**Design Review & Historic Preservation Board  
Agenda  
March 23, 2023**

**Design Review and Historic Preservation Board**  
**Minutes**  
**March 9, 2023**

5 Building Section  
1/4" = 1'-0"

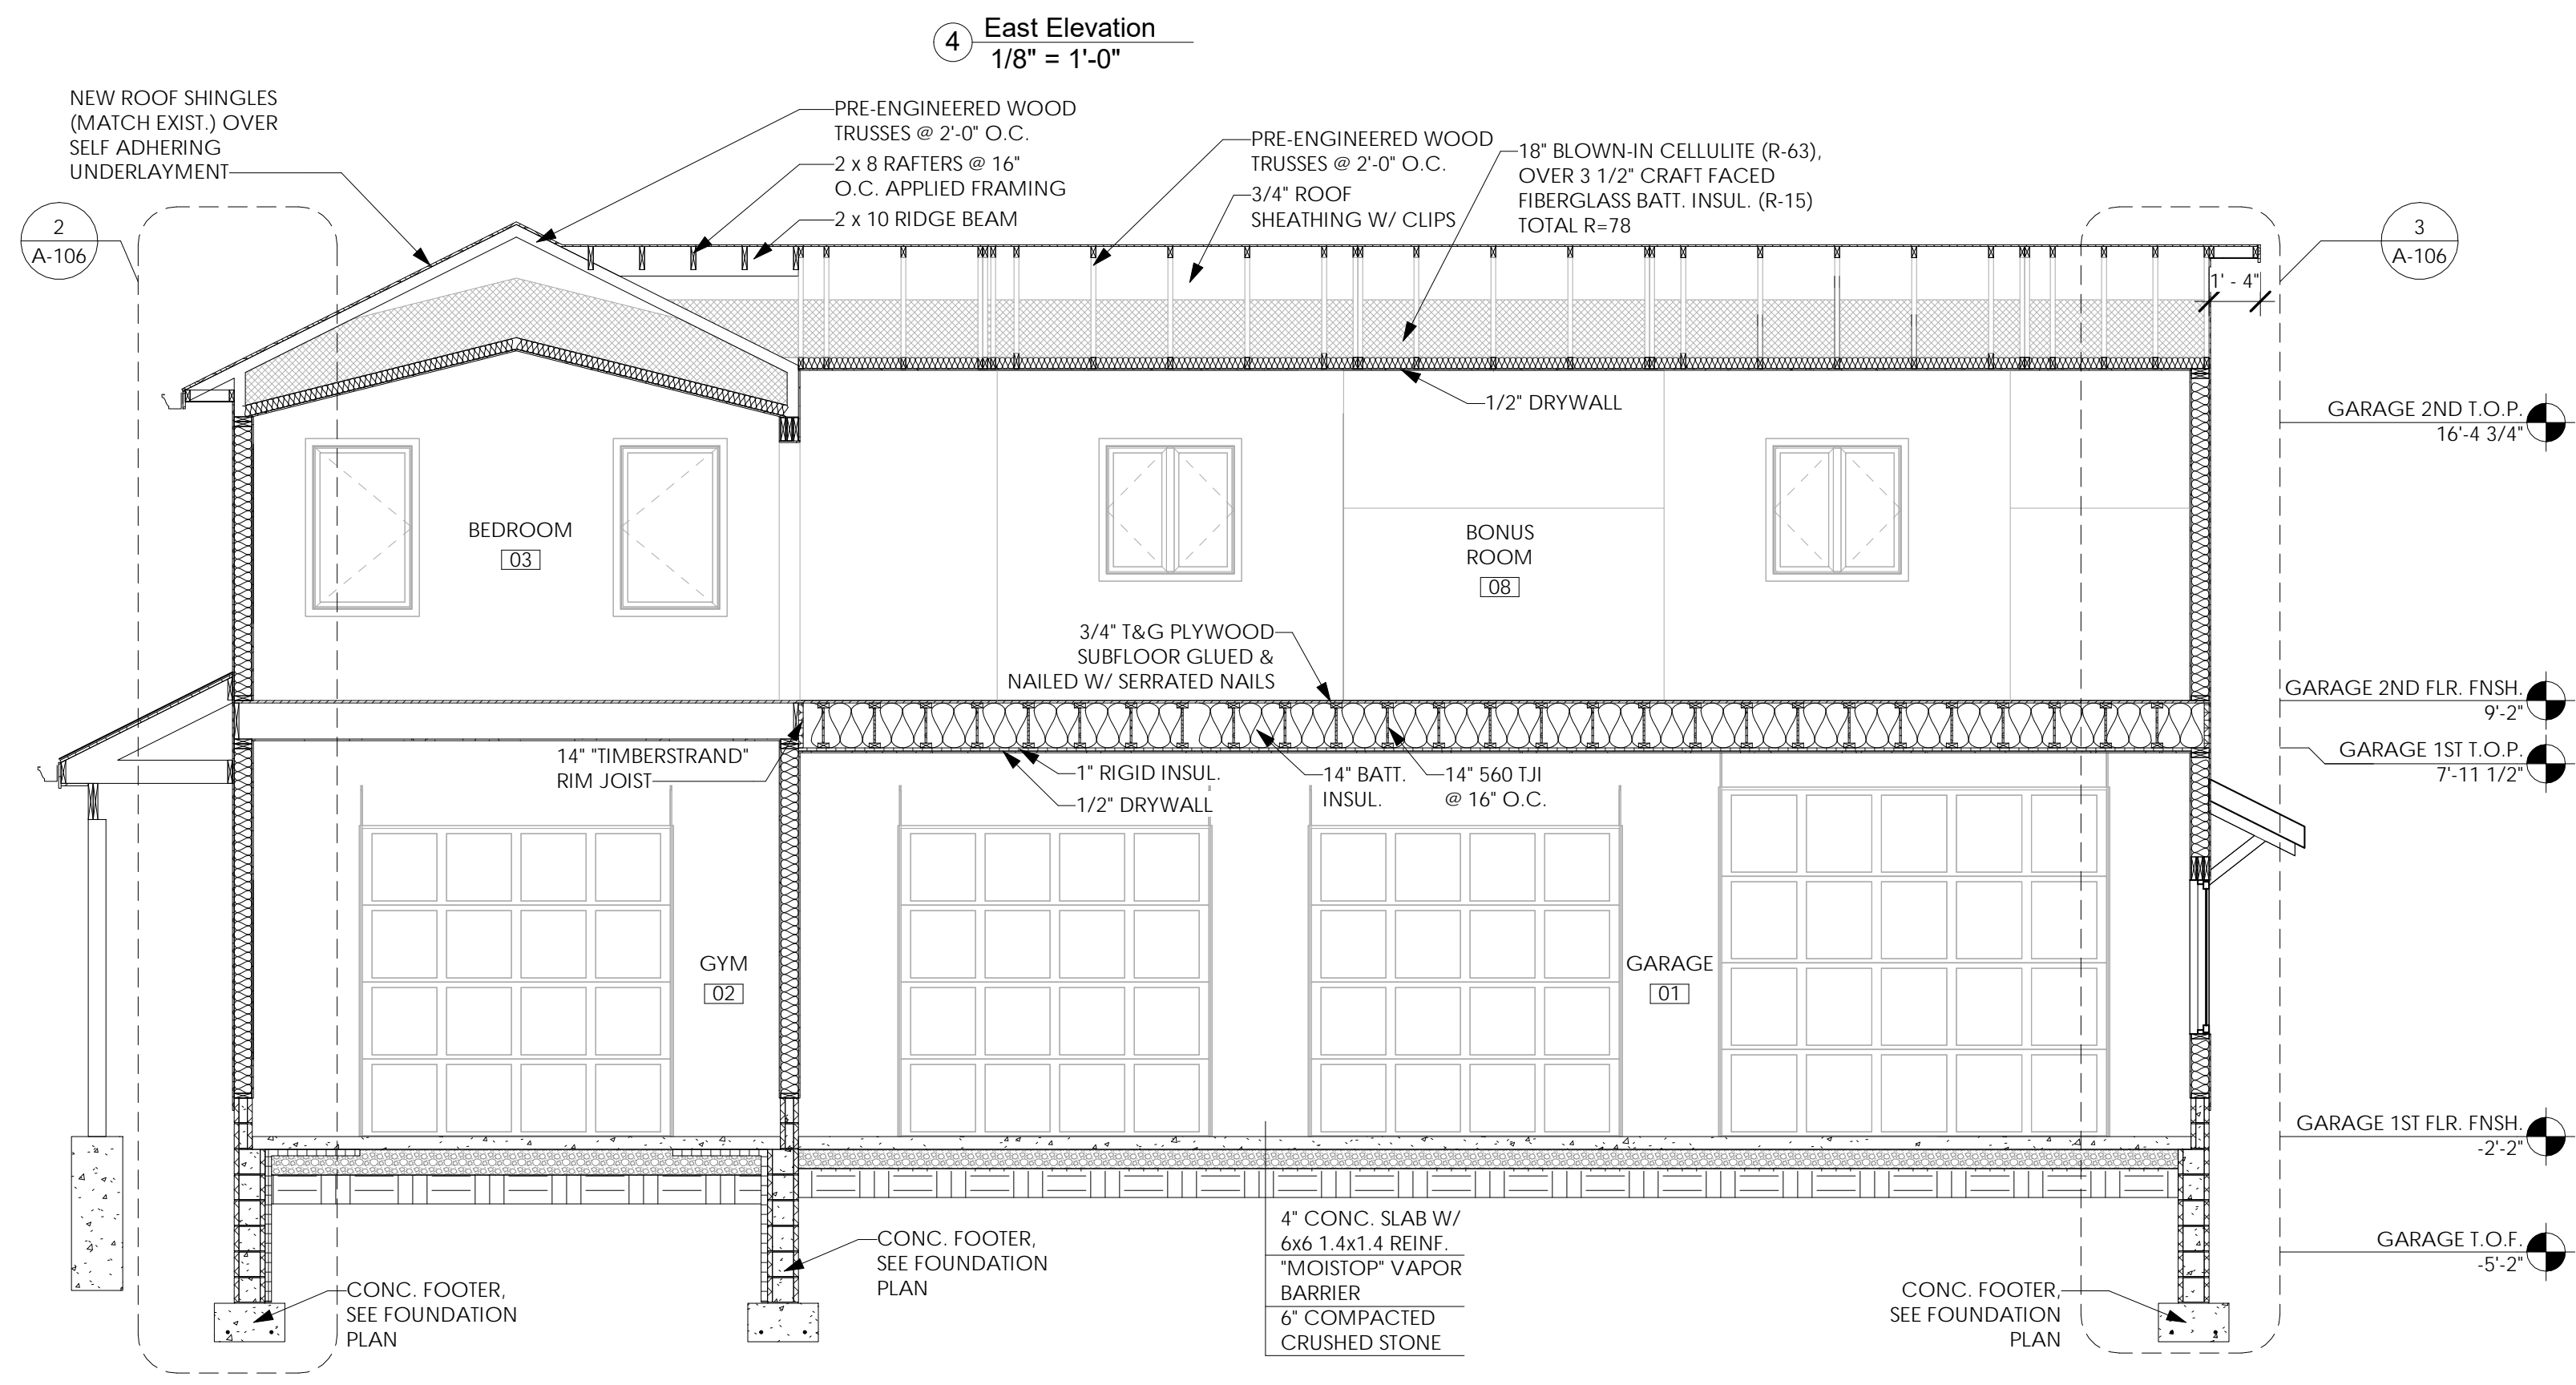
Mr. Young is proposing to demolish a current one car garage and replace with a 4-bay garage addition. The garage addition will be stepped back from the main structure and turned perpendicular to it facing Pittsford Henrietta Town Line Road. Living space is proposed above the garage bays. One of the bays is proposed to have a larger door to accommodate potential future boat storage. Mr. Young indicated that the windows and roofing materials will match the existing on the home. The style of garage doors has not been determined.

The Board raised concerns that the proposed garage addition is too large in relation to the existing home. They asked if the current trees would remain, and Mr. Young indicated that one will need to be removed to achieve the construction of the garage and one is currently blocking the view of the road.

David Wigg suggested a breezeway between the garage and home, but the homeowner preferred not to pursue that option.

Kathleen Cristman suggested making a smaller garage or having a detached garage design to break up the massing of the garage.

The elimination of one of the ridges was also suggested.

The motion failed to carry.
